37/03-04A 7307 Piney Branch Rd
Takoma Park Historic District

SUBJECT: Historic Area Work Permit # 329171

HISTORIC PRESERVATION COMMISSION STAFF REPORT

PROPOSAL: Porch Floor Replacement (RETROACTIVE), and various other alterations

Wood Decking For 1st Floor Porch

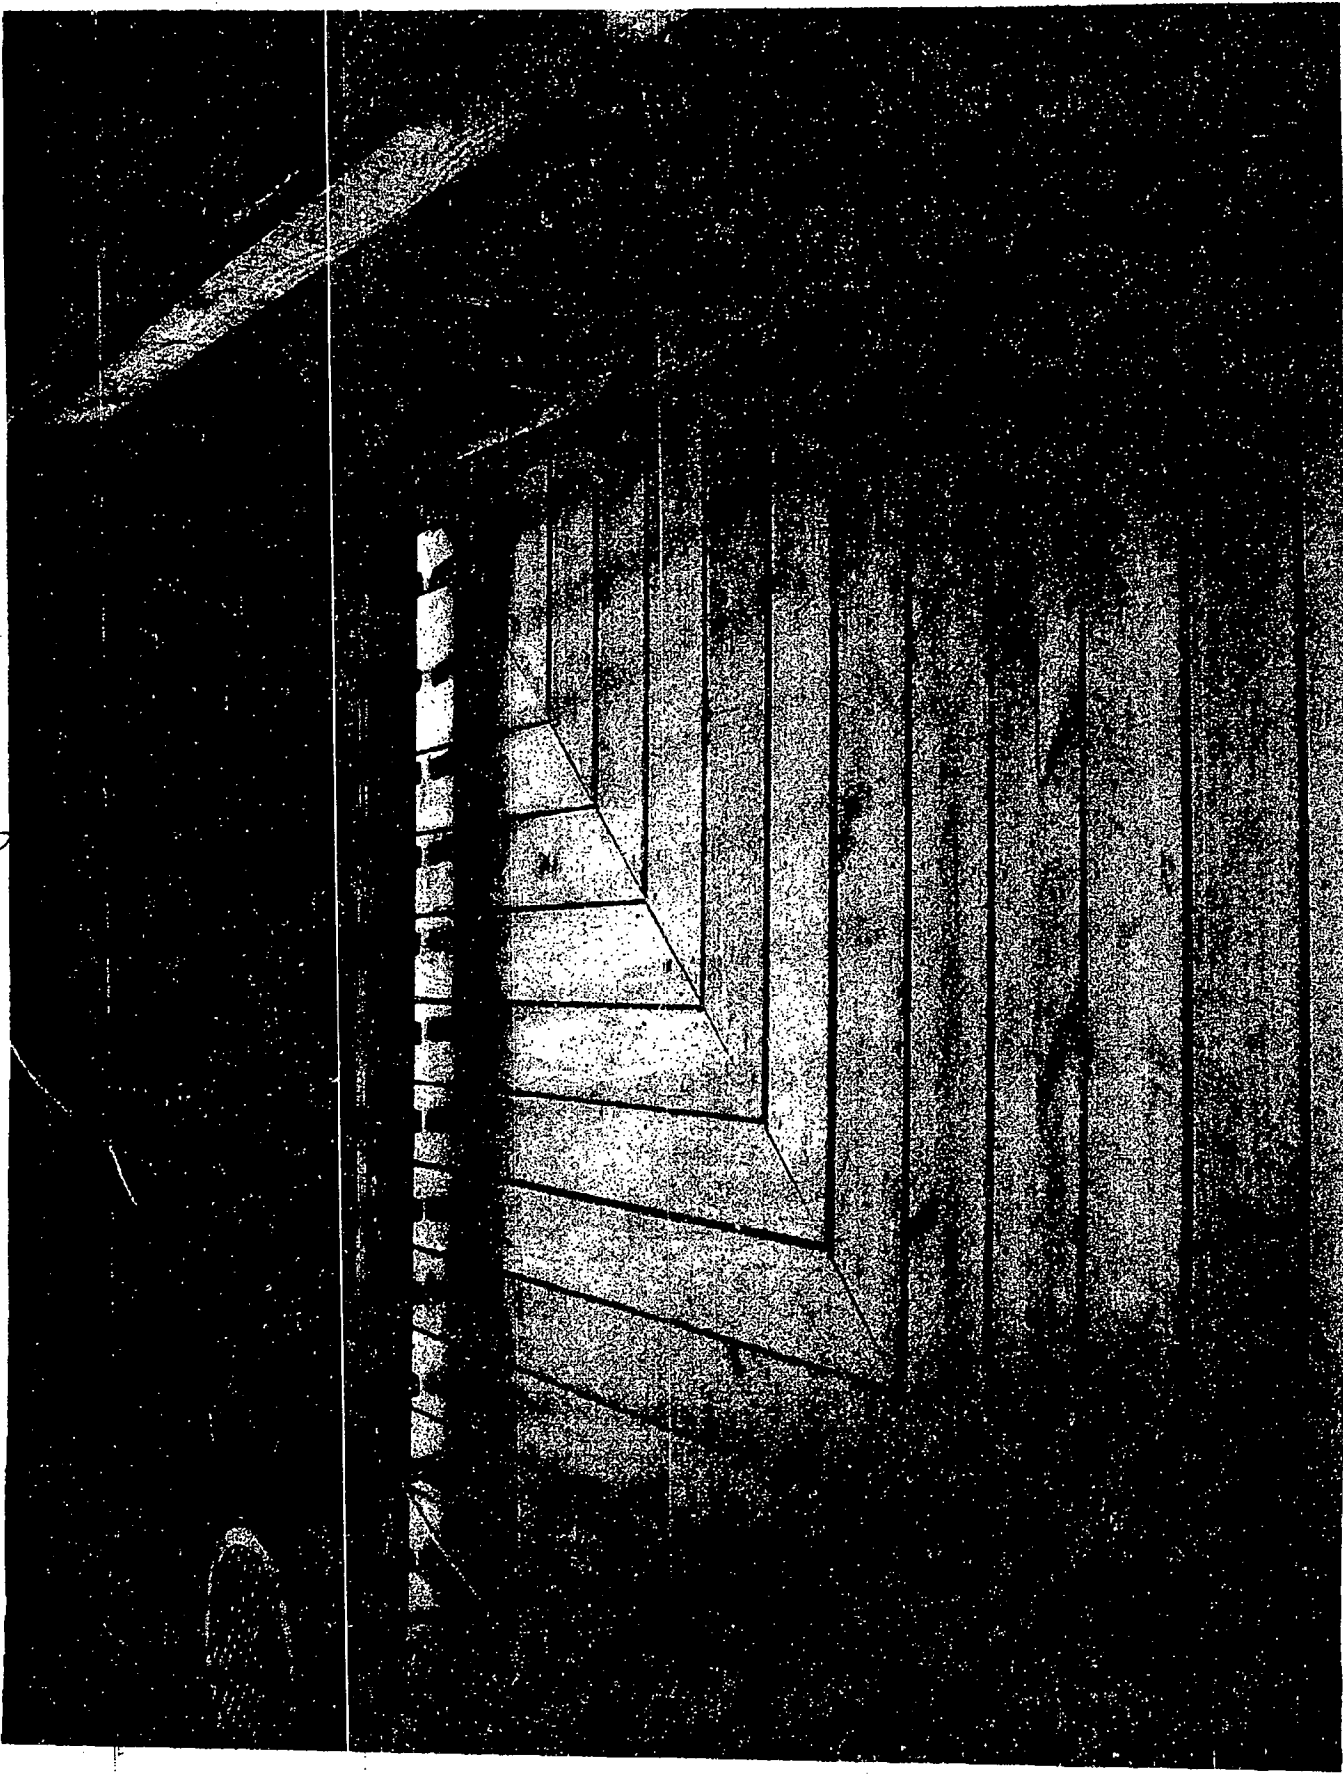
PorCH Floor installation - partial Retroactive.
proposed = 5/4 6" pressure treated planks -
needs to be tongue + groove.

1. The front porch floor is replaced with painted or stained, wood, tongue and groove flooring. *3.5' - Replace w/ in 2 yrs. compatible material.*
2. The ~~3'~~ *3.5'* high fence is approved in concept, yet requires that the applicant receive approval of the design from HPC staff prior to the fence's installation. *3.5' painted or stained.*
3. The gutter replacement is approved in concept with the condition that the design of the metal replacement gutters will be reviewed and approved by HPC staff, prior to their installation.
4. The replacement of the front, wrap-around porch's balustrade is approved in concept, with the condition that the applicant will work with staff to develop a balustrade design that will be compatible with the existing historic fabric of the house.

Front Gable
Metal
Roofing

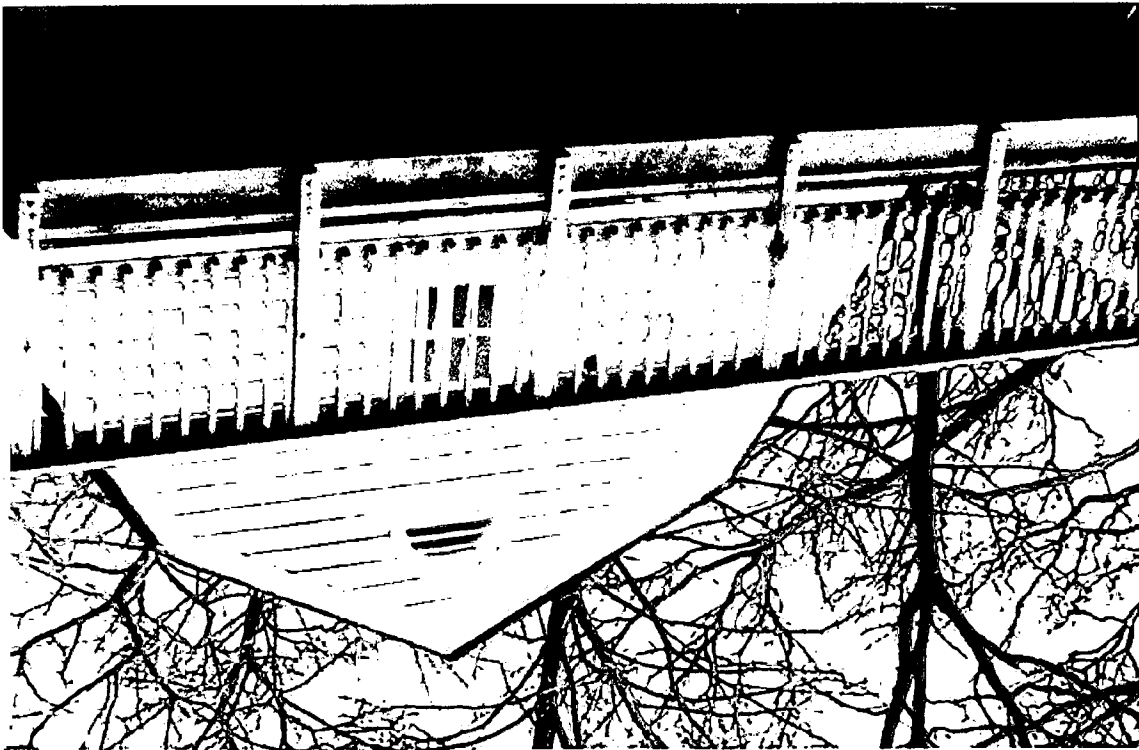
Front + side porch re-roofing w/ metal.
standing seam? need specs.

A standing seam metal roof is considered a compatible building material for the project. Staff recommends approval noting that the installation and material costs for this project are tax credit eligible.
